FROM STEVEN MENDELSON,
StevenMendel2001@ Yahoo.Com

As you know I am the owner of the lot immediately to the south of the proposed development **PLN50589** As you know are aware the easement **AFB 200103260191** refers to an easement on Lot B and adjacent to my property immediately to the south.

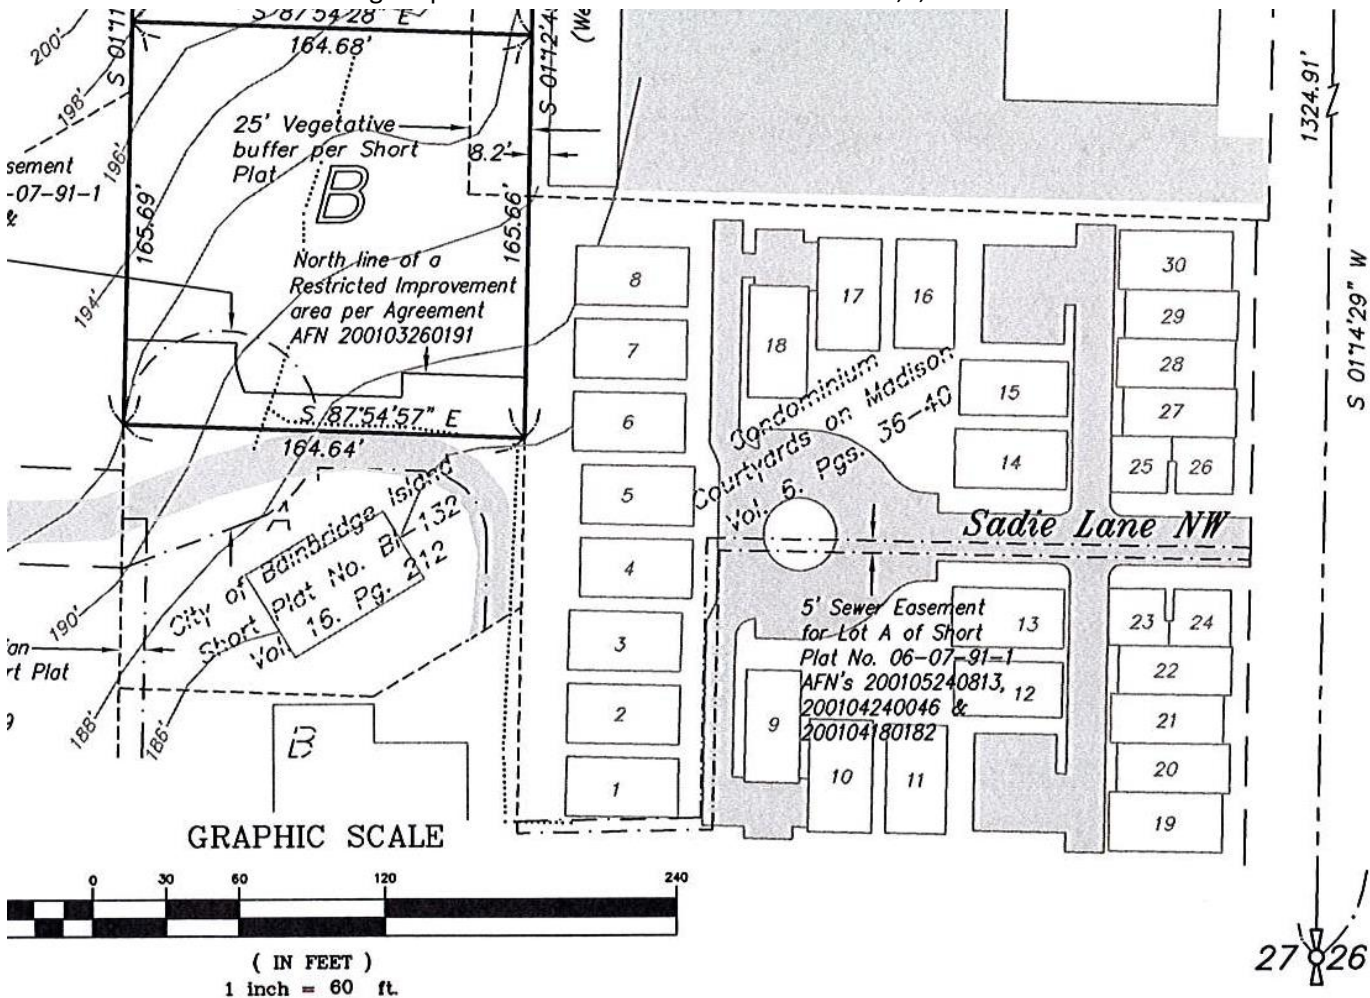
1. Specifically both drawings below shows a setback of 18.56 feet between Lot 8 and the southern boundary line of lot B. However, **AFB 200103260191** specifies a setback of 35 feet. My understanding from the builder is that the plans have changed and that the drawing on the SEPA document are likely in error and reflect an older document. Be that as it may, the SEPA plan as it stands is likely in error and I feel the SEPA plan should be corrected specific parties involved have ample time to review it. Once again, I point out that we were informed by the city that we were one of the properties did not receive the initial notification of the SEPA application.

2. Another concern is that "Open Space" is shown immediately to the south of Lot 8. Given the fact that the placement of lot 8 is likely off by 20+ feet to the south I do not know where the open space is intended to lie.

3. However assuming the open space lies within the easement.. **AFB200103260191**. Then there is likely conflict between the City's open space management plan (specifically fencing- and restrictions of the easement's fencing requirements). The city management plan contains the wording *"A low impact fence eg split rail delineating the boundary of the open space area shall be maintained along the boundary between the open space and the lot or right of way."* I have two problems with the above conflict.

- I find the language of the open space manage plan vague wherein the wording "lot or right of way" lacks clarity. As outline above specific drawing (below) detailing the open space most likely contains substantial error in the placement of Lot 8 (off by 20+ feet to the south) In other words, will the "open space" lie within the easement or

will it be adjacent to the north border of the easement or both?

4. In either case above (ie. open space either within the easement or immediately north of the easement) *the easement AFB 200103260191 clearly specifies the details of a solid fence (ie. Not split rail). Furthermore this fence is currently in place and illustrated on the drawing below.* Therefore, the potential requirement for a split rail either along my property or along the north side of the easement could create a future legal issue between the builder, myself and the city.
5. Additionally the "utilities easement" AFB (?) has not yet been signed off on by the parties involved. Further comment on the "utilities easement" is offered on the addition to this document (06-15-2018) See below.

ABOVE ITEM is 4/22/1028 Revised Opens Space Management Plan 4-10-18.PDF The southern most aspect of this drawing outlines a "Restricted improvement area per agreement 920003260191

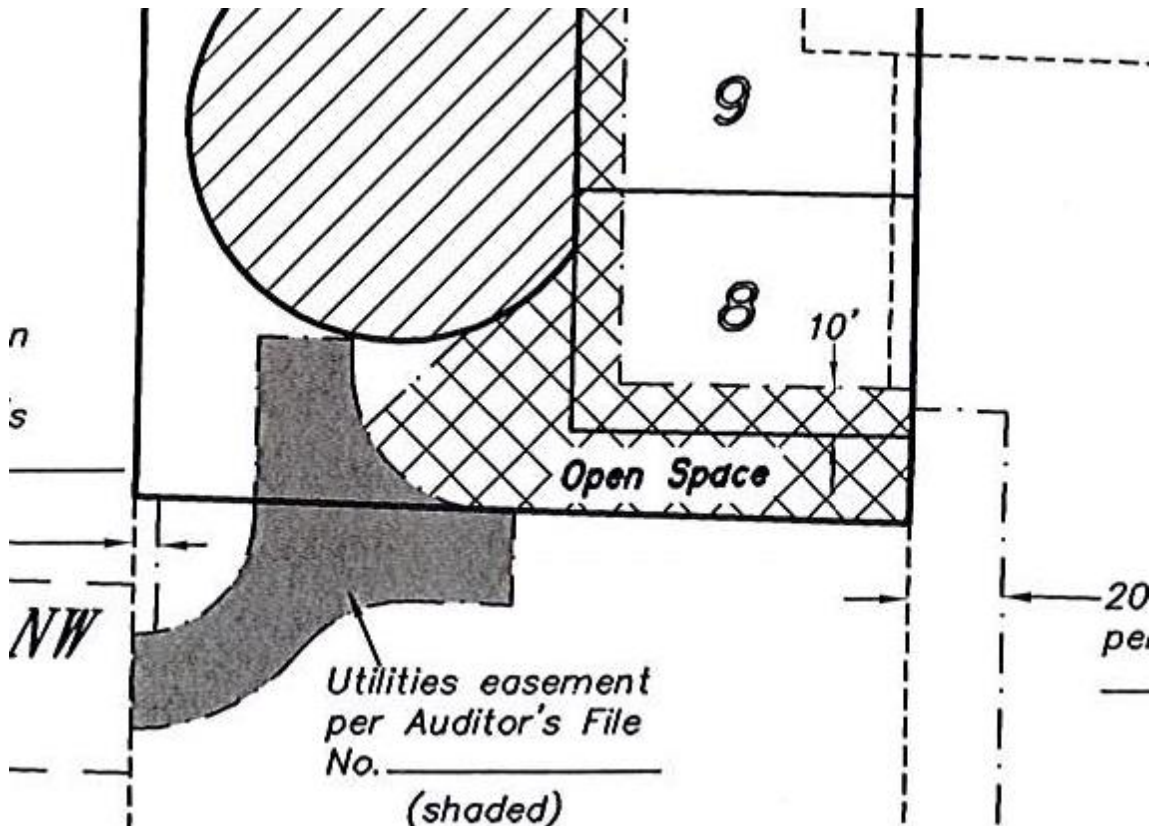
Furthermore The same document below shows the same land as "Opens Space" and does not show that it is in fact a "Restricted Improvement area per Agreement 920003260191"

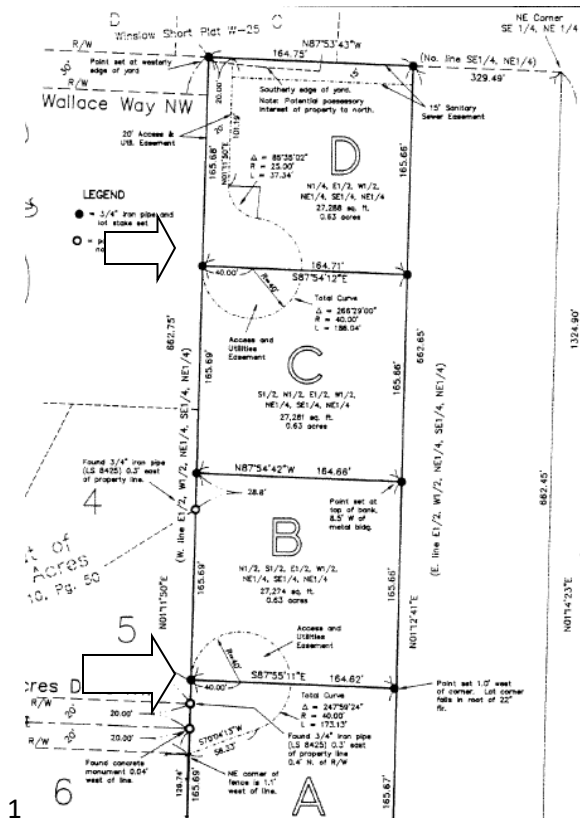
I believe there may be an issue concerning the "Utilities easement" as shown above.

The plans show water to the development both across my property but also coming in from the north end of the development. The water line runs entirely north-south through the development.

However as per the original Plat(see drawing below) a utility easement across my property only serves Lot B (ie the southern most aspect of the development.)
